Equalization and Jitter Transfer Function (JTF) Proposals for nAUI of IEEE 40G/100G Specification

Mike Li, Altera
November, 2008
Dallas, TX

Equalization Proposal for nAUI

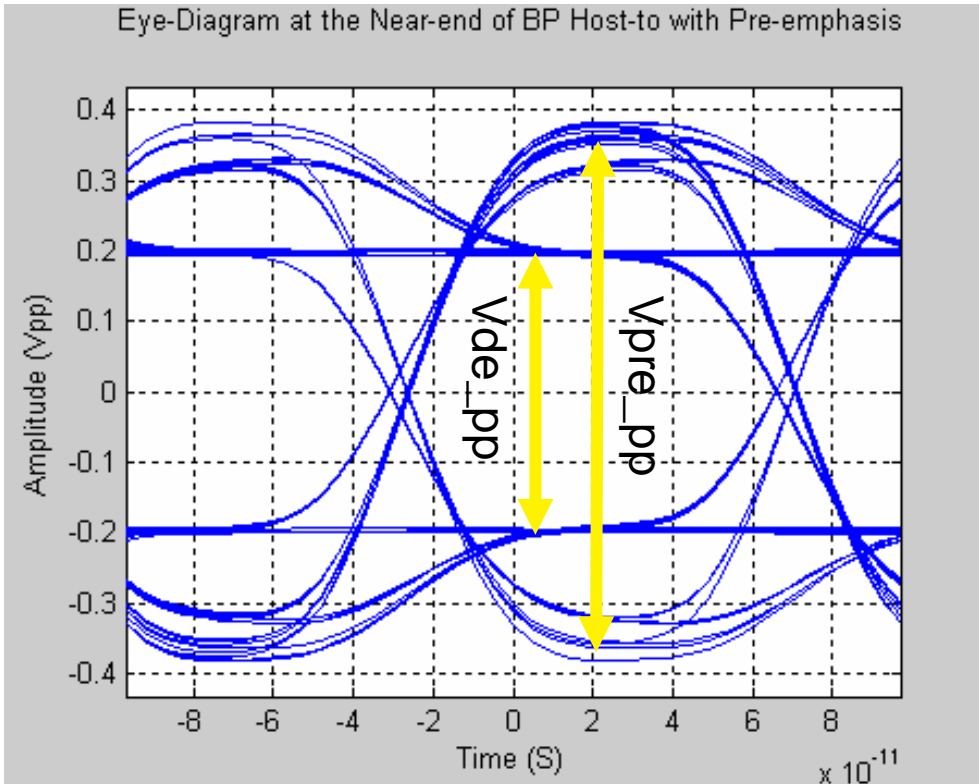
Hole #1 With the D1.0 nAUI: Equalization Not Specified

- In D1.0, Annex 83A, section 83A.3.3, P283, transmitter and/or receiver equalization is not defined or assumed. As such the assumption that channel jitter is not compensated is used in the specification. This will eat the DJ margin of Tx and Rx while most of them today have the equalization capabilities, or will leave channel jitter margin unused, making nAUI specification unnecessary expensive.

- Tx equalization:
 - Pre-emphasis/de-emphasis with 5.5 dB ratio
- Rx equalization:
 - CTLE, frequency response mask TBD

$$Pre_de_ratio = 20 * \log_{10} \left(\frac{V_{pre_pp}}{V_{de_pp}} \right)$$

Jitter Transfer Function (JTF) Proposal for nAUI

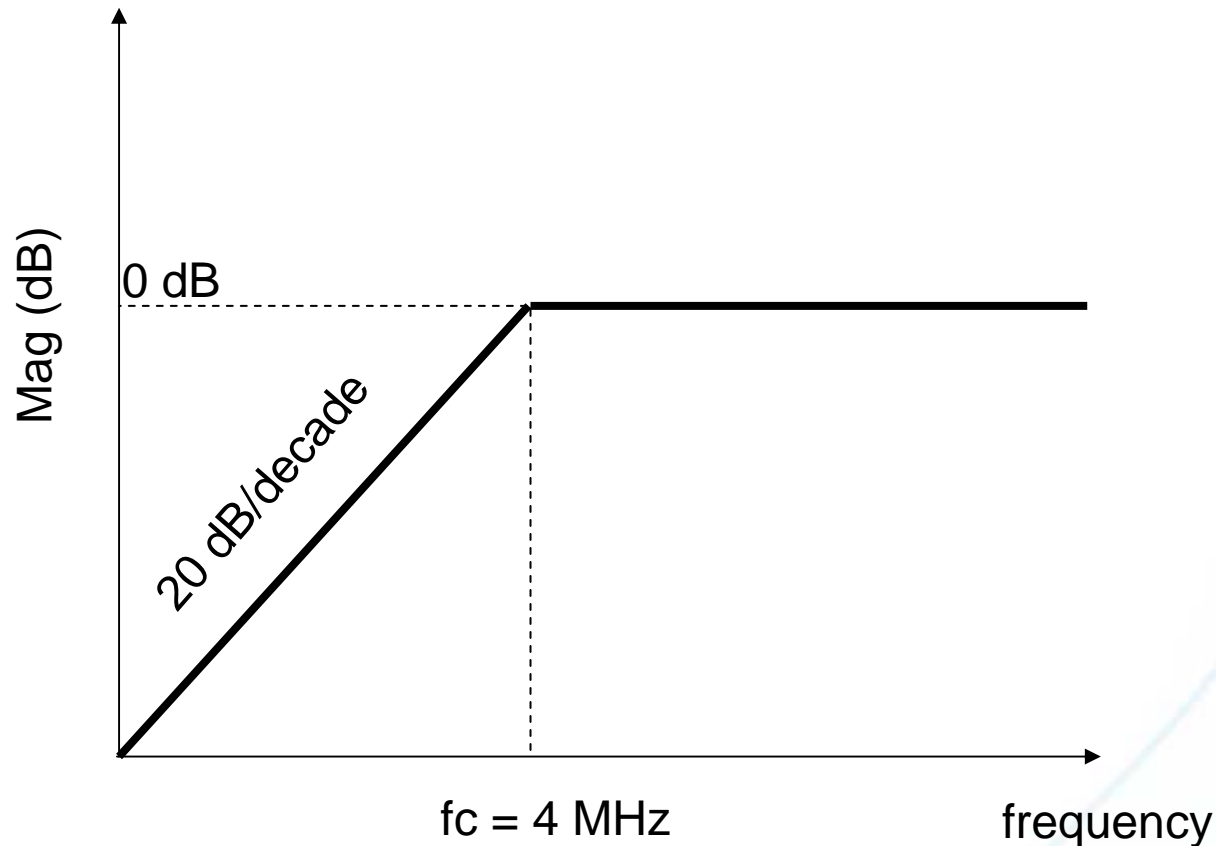
Hole #2 With the D1.0 nAUI: Clock Recovery Jitter Transfer Function (JTF) Not Specified

- In D1.0, Annex 83A, section 83A.3.3, P283, jitter transfer function (JTF) is not defined for Tx jitter definition/testing. This will grossly overestimate the Tx jitter, leaving the jitter margin available by clock and data recovery (CDR) unused, resulting in expensive nAUI specification.

- “Golden PLL” similar to Fibre Channel-MJSQ
- Should be used for Tx jitter testing
